INCOMPLETE APPLICATION MEMORANDUM

RE: Application Completeness Review
New Proposed Wireless Facility: Public Right-of-Way
at approximately 1544 Kenneth Road (Adjacent to APN #
5622-027-018)

RADIO FREQUENCY PLANNING MEMORANDUM

TO: Mr. Soroush Sheikhlari and Mr. Benjamin Gonzalez
FROM: Dr. Jonathan Kramer
DATE: April 26, 2023
RE: (Glendale 237)(EP 823) Radio Frequency Review for
Proposed New Wireless Site-Mounted on Replacement
Pole near 1544 West Kenneth Road.

Figure 1: Overview of Pole location (Source: Plans, page A-2, panel 1).

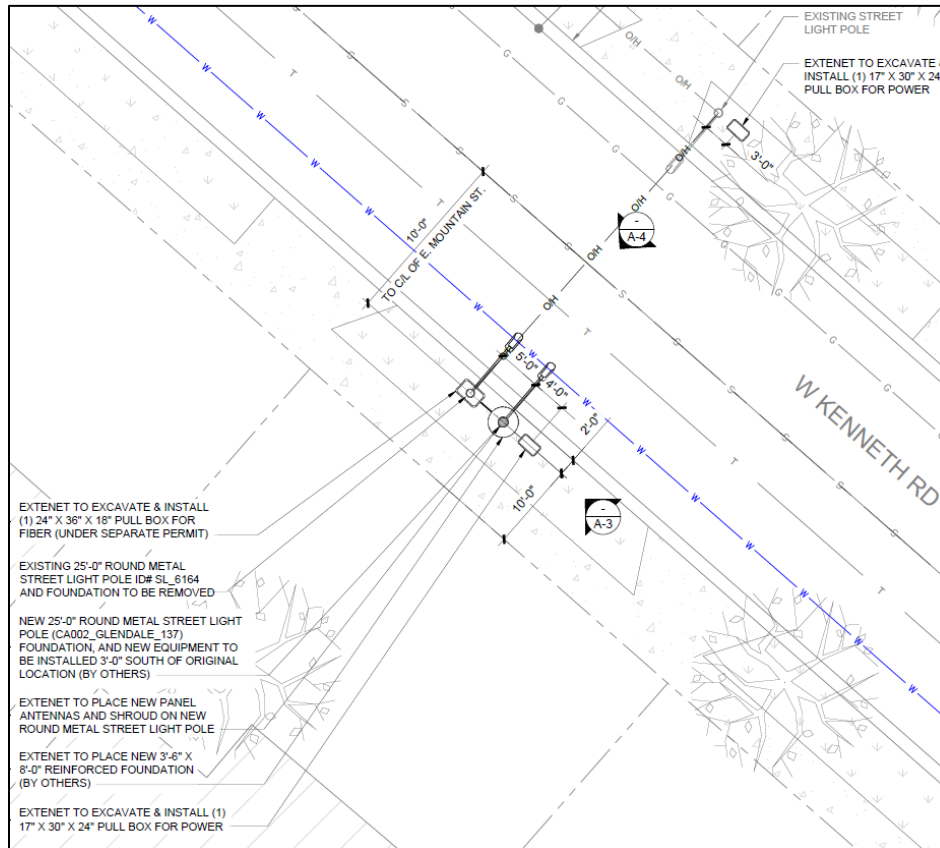
TLF notes the existing overhead power on the original structure needs to be undergrounded.

Figure 4: Proposed antenna orientations (Source: Plans, Page D-1, panel 1).

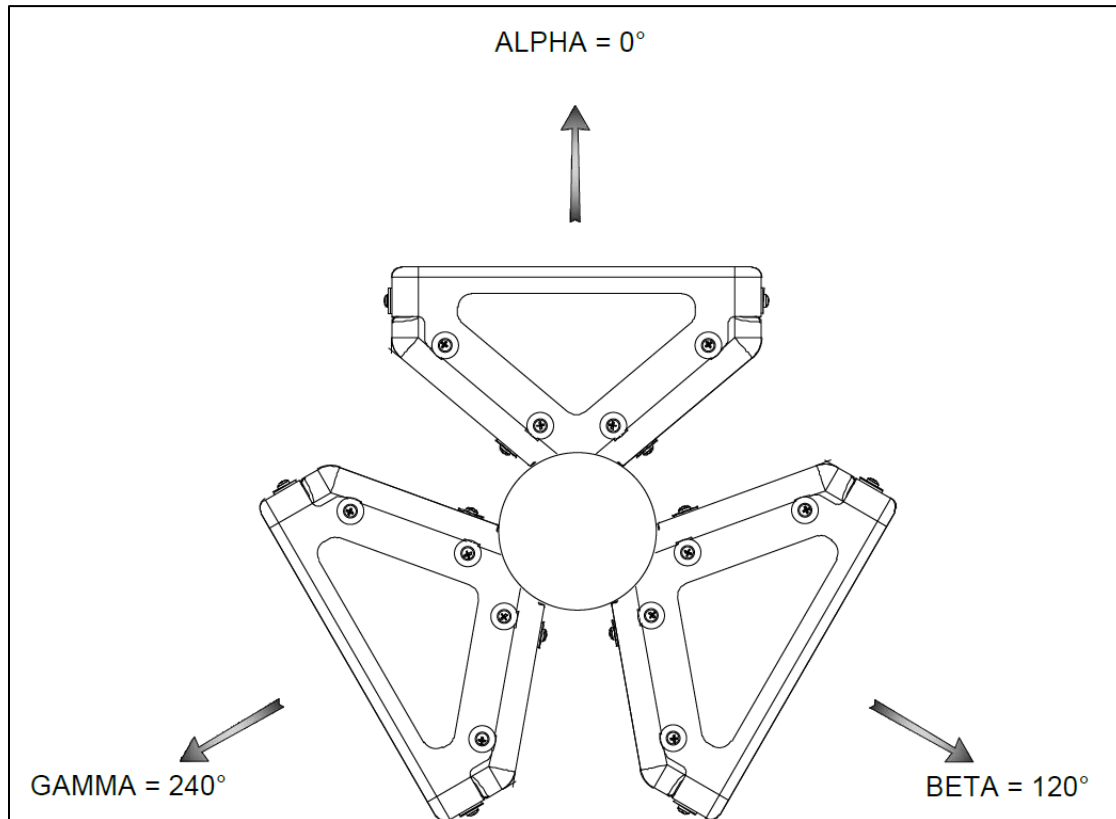
The antennas will orient in a 360° direction with Sector Alpha oriented toward 0° True North ("TN"), Sector B oriented toward 120° TN and Sector Gamma oriented toward 240° TN, see Figure 4.

Based on the antenna power emissions, Verizon’s antennas will create a “controlled access zone” for all three sectors that extends approximately 6 feet horizontally from the face of the antennas at approximately the height of 27' AGL.

Figure 5: Proposed elevation view from the north (Source: Plans, Page A-3, panel 2).

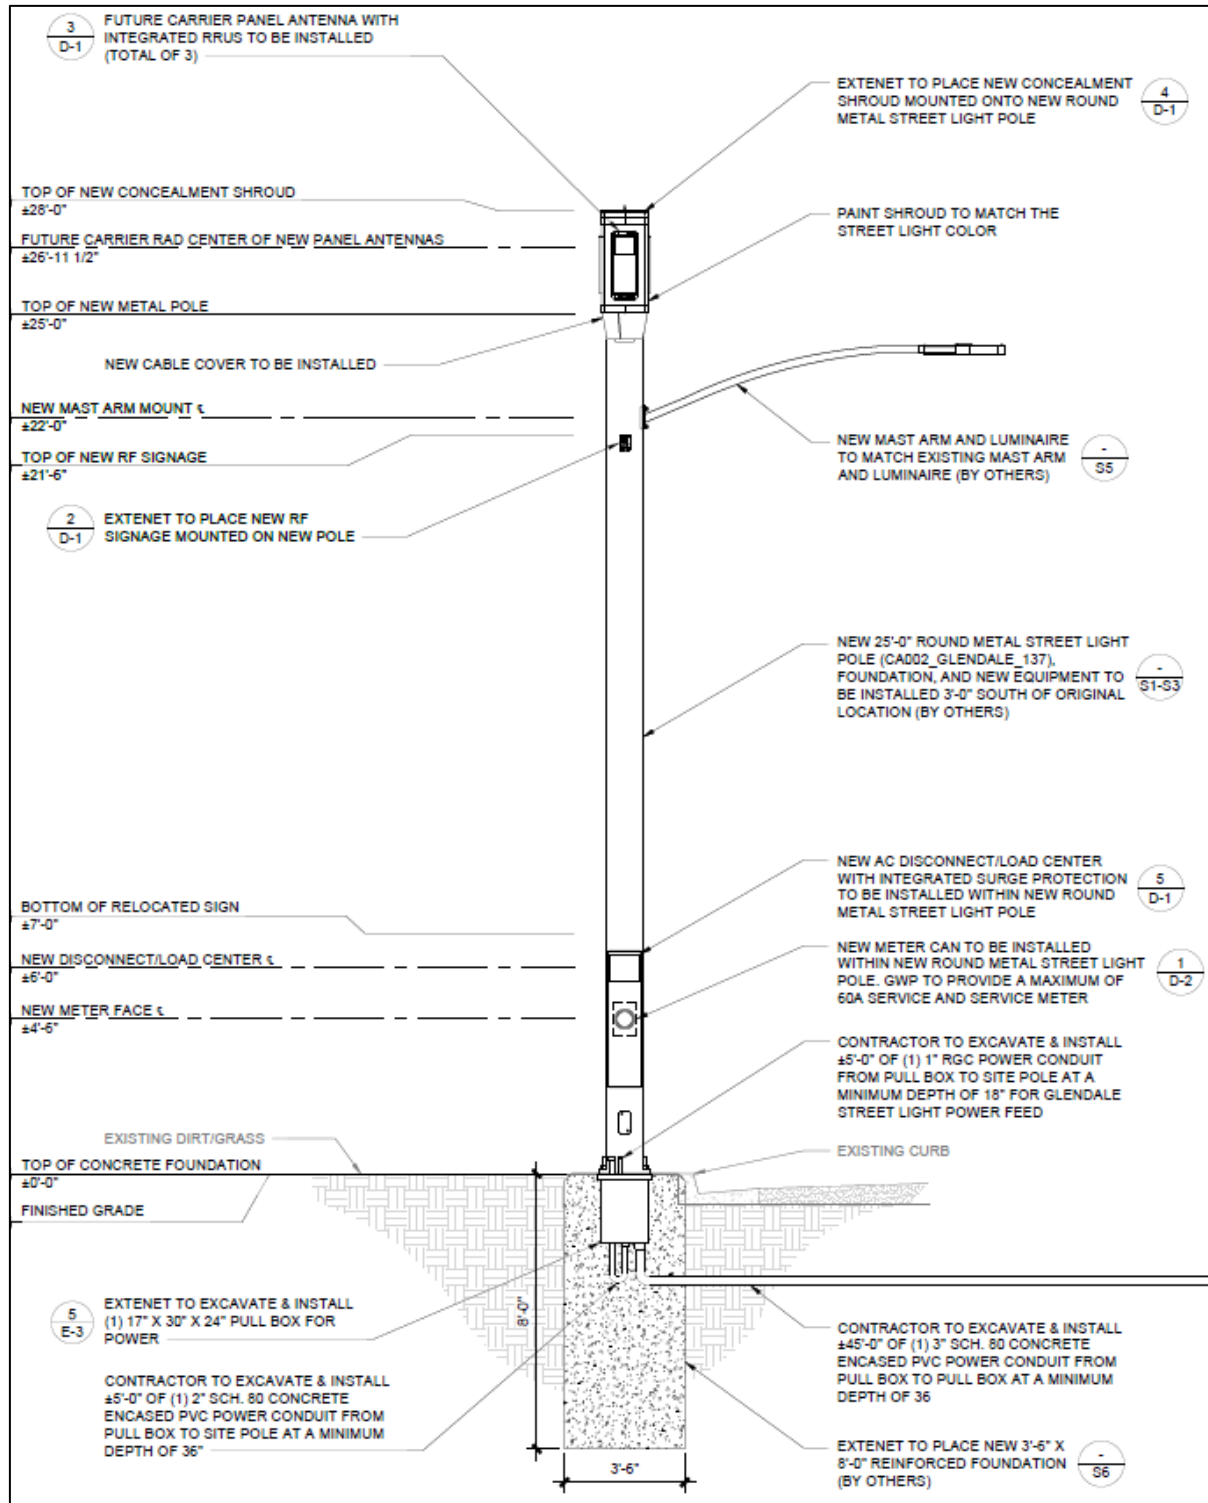
The proposed antennas are to be mounted with the centerline height of approximately 27' AGL. Verizon's proposal is depicted in elevation with details in Figure 5.
